## **Design Review Meeting – I-70 Floyd Hill to Veterans Memorial Tunnels Project # NHPP 0703-446 (21912)**

## I-70 Floyd Hill to Veterans Memorial Tunnels

**Project:** I-70 Floyd Hill to VMT NEPA and 30% Design  
**Meeting:** Design Review Meeting  
**Date:** Monday, July 23, 2018 and Tuesday, July 24, 2018  
**Location:** CDOT CTMC

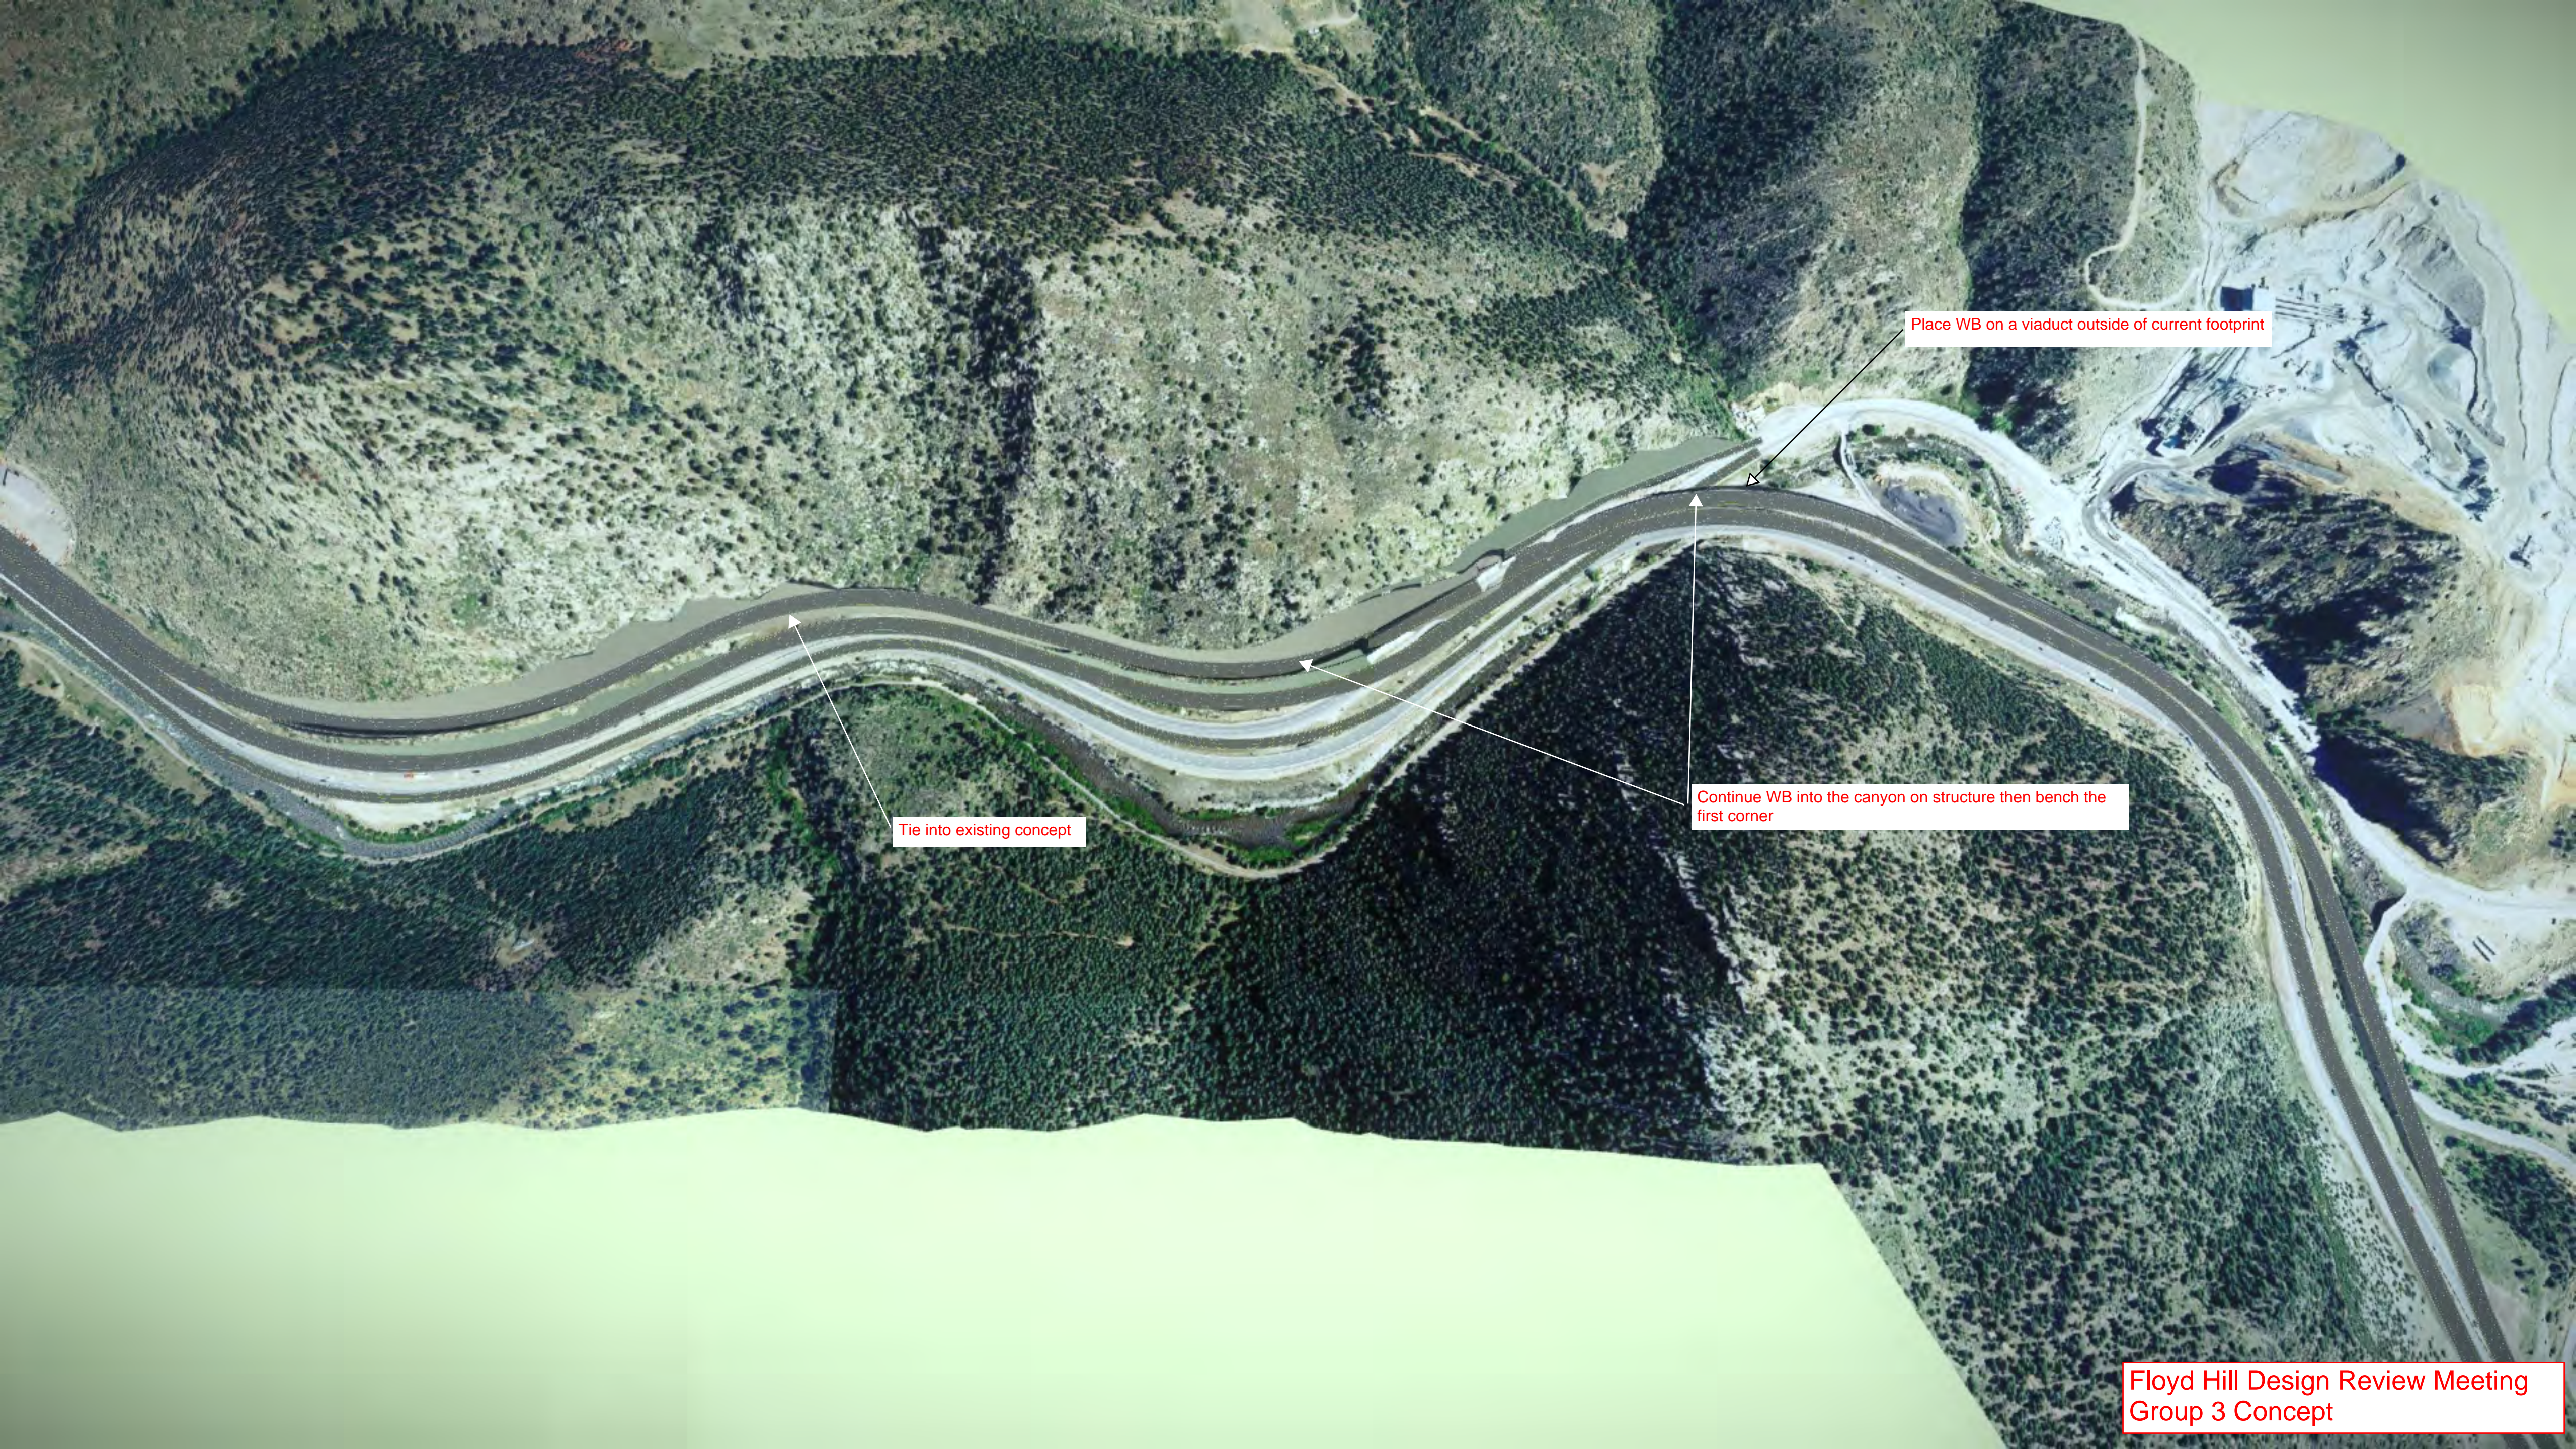
EB crosses the canyon onto a bench

Shift WB on to existing EB lanes and under the new EB bridge.

Place Fill along toe of landslide, Move EB onto the fill

EB alignment shift clips landslide in this area

Opportunity to add new WB I-70 on ramp from US 6 in this area

Tie into existing concept

Continue WB into the canyon on structure then bench the first corner

Place WB on a viaduct outside of current footprint

- a) Group 1 concept.
    - i) It wasn't possible to place fill along the EB lanes and shift the lanes onto the fill without cutting into the landslide.

- i) This concept has merit and is feasible. It will be considered further.
  - d) Braid I-70 and put EB in the tunnel instead of WB concept.
    - i) This concept has merit and is feasible. It will be considered further.
-
